Exhibit 6: Nederlander Theater

Exhibit 6B: Architectural Modifications

Exh. 6B Architectural Modifications to Nederlander Theater

**ACCESSIBLE TOILET ROOM
AT ORCHESTRA LEVEL**
N.T.S

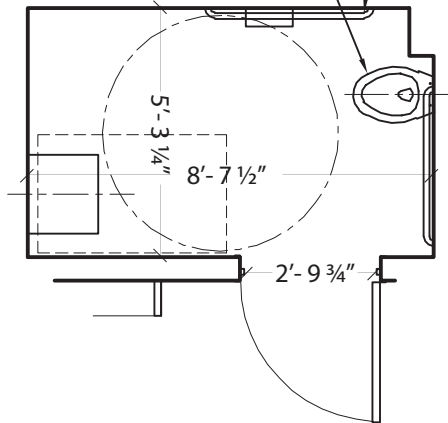
RELOCATE WATER
CLOSET TO 18" FROM
SIDE WALL

RELOCATE SIDE
GRAB BAR TO 12"
MAX FROM REAR
WALL

52	Orchestra Level (Accessible Toilet Room)	The water closet is 23" from the side wall adjacent to lavatory.	The centerline of the water closet is more than 18" from the side wall.	4.1.3(11) 4.22.4 4.16 Fig. 30	Defendant will relocate water closet at compliant distance from side wall.
53	Orchestra Level (Accessible Toilet Room)	The side grab bar is mounted vertically from 18" to 35" AFF. It is 16" long and is mounted 2" from the wall.	Toilet room side grab bar is not mounted horizontally between 33" and 36" AFF. It is also less than 42" long and is more than 12" from the rear wall.	4.1.3(11) 4.16.4 4.22.4 4.26 Fig. 29	Defendant will provide compliant side grab bar.
54	Orchestra Level (Accessible Toilet Room)	There is no rear grab bar.	There is no rear grab bar in the "accessible" toilet room.	4.1.3(11) 4.16.4 4.22.4 4.26 Fig. 29	Defendant has provided compliant rear grab bar during course of investigation.

**MEN'S TOILET ROOM
AT MEZZANINE LEVEL**
N.T.S

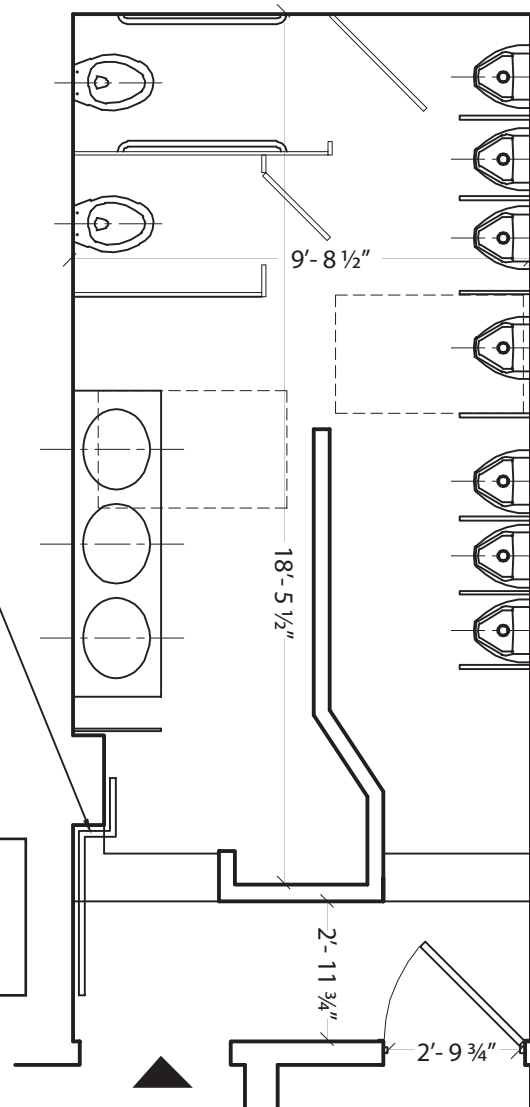
NEW HANDRAIL

37	Mezzanine Level (Men's Toilet Room)	There are 2 steps without a handrail rising 14 1/2" from the main Mezzanine level to the toilet room. There is an unusable "accessible" toilet room provided on the orchestra level.	Toilet room is on a level not served by an accessible route.	4.1.3(5) 4.1.6(1)(b) 4.1.6(2) 4.3.2(3) 4.3.8	Defendant will provide compliant handrail.
38	Mezzanine Level (Men's Toilet Room)	There are 2 stalls in this toilet room, with 59" total width, neither with grab bars.	There are 2 toilet stalls in this toilet room which is on a currently inaccessible level but which appears to have been altered since the ADA requirements went into effect. Neither of the stalls are accessible.	4.1.3(11) 4.1.6(1)(b) 4.1.6(1)(k)(ii) 4.1.6(3)(e)(iii) 4.17 4.22 4.22.4 Fig. 30(a)	Defendant has provided ambulatory stall and will remove urinals, for side approach clearance, upon compliance with local plumbing codes.

Exhibit 6C: Seating

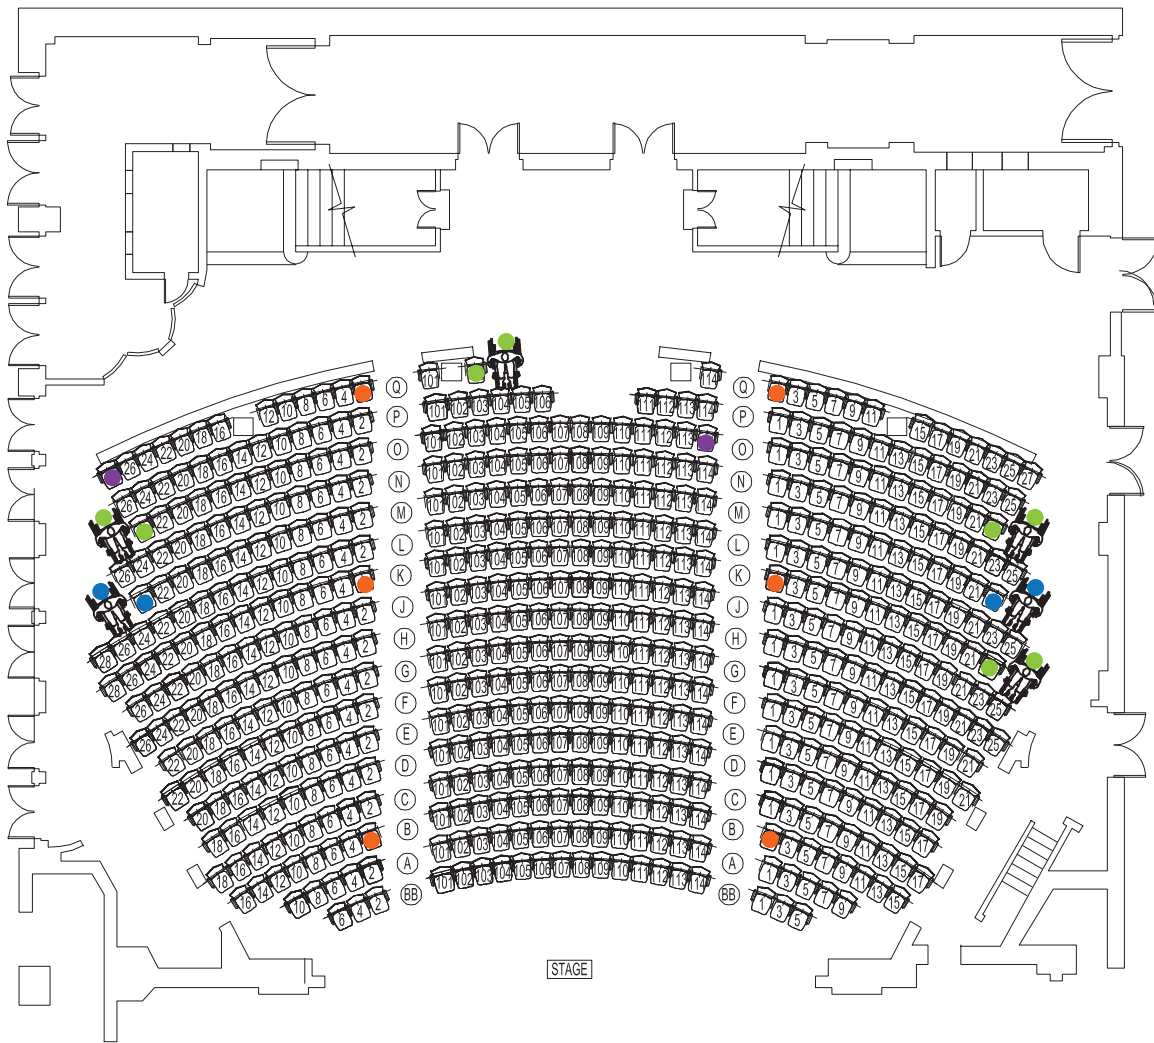
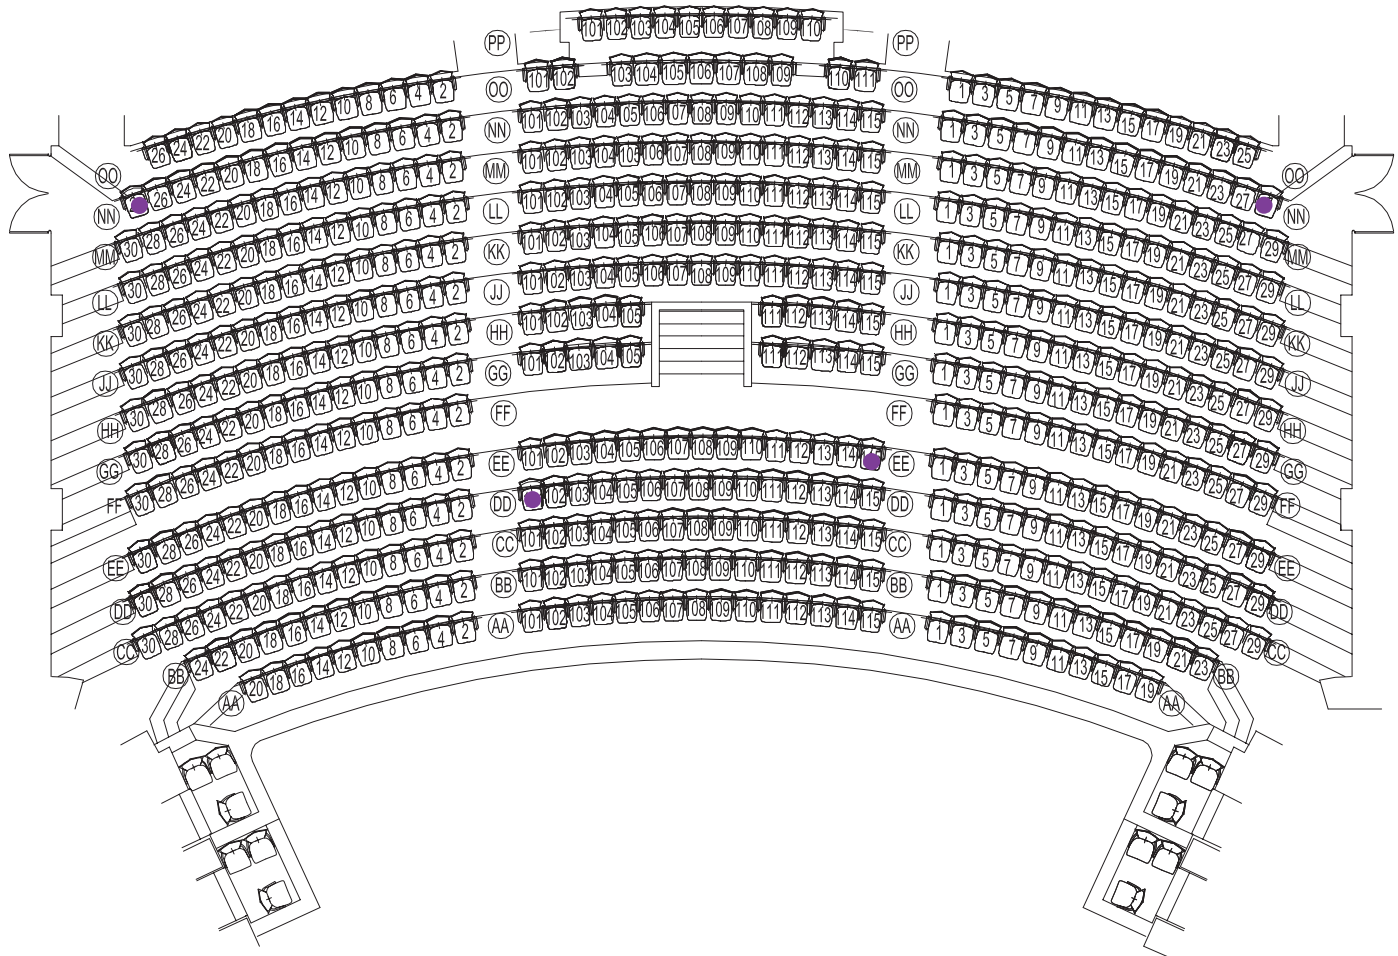
1. Nederlander shall maintain the four existing wheelchair and companion seating locations on the Orchestra level at K25, O25, Q104, and O26, with K23, O23, Q103, and O24 being companion seating locations.
2. Nederlander shall bring the wheelchair seating location at K25 into compliance with the Standards.
3. Nederlander shall remove seat P25, which blocks egress from the wheelchair seating location at O25.
4. Nederlander shall add two new wheelchair seating locations on the Orchestra level, M25 and M26, with M23 and M24 being companion seating locations.

5. Nederlander shall maintain the six existing aisle transfer seats on the Orchestra level, at B1, B2, K1, K2, Q1, and Q2, and add two new aisle transfer seat on the Orchestra level at Q28 and O114, and four aisle transfer seats on the Mezzanine level at DD101, EE115, NN29, and NN28.

Nederlander shall implement the seating plan attached hereto as Exhibit 6C.
